Subject: Safety Recall SET17B– *Remedy Available* Certain 2011-2016 Model Year 4Runner and Tacoma Vehicles with SET installed Hood Scoop

Tacoma/4Runner Hood Scoop Recall SET 17B Frequently Asked Questions (FAQ)

Certain 2011 – 2016 Model Year Tacoma and 4Runner Accessory Hood Scoop IMPORTANT SAFETY RECALL

Remedy Procedures

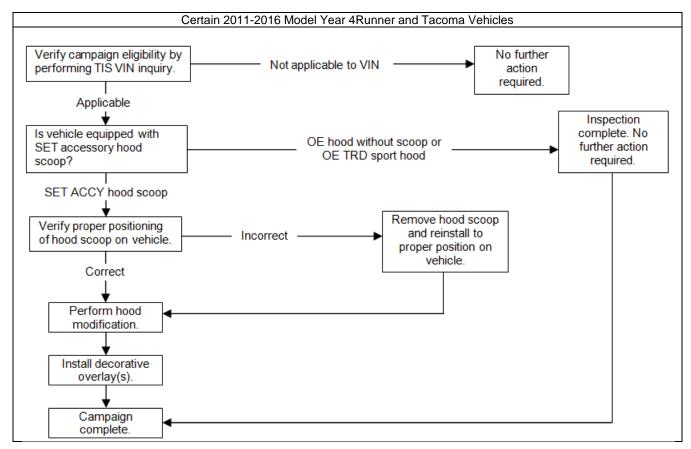
SET either installed or sold to dealers to install accessory hood scoops for 2011-2016 Toyota Tacoma and 4Runner vehicles. The hood scoop is attached directly to the vehicle hood with double sided adhesive tape specifically designed for automotive applications such as hood scoops and body side moldings. SET has determined that over time the adhesive backing on the tape may degrade reducing adhesion to the hood which could lead to detachment of the hood scoop from the vehicle and increasing the risk of a crash for following traffic.

Southeast Toyota has prepared a remedy for this condition. Toyota dealers will, affix the hood scoop to the hood using machine screws with nylock nuts and apply a decorative overlay.

Please refer to TIS for Technical Instructions on repair. Conduct all applicable, non-completed Safety Recall and Service Campaigns on the vehicle during the time of appointment.
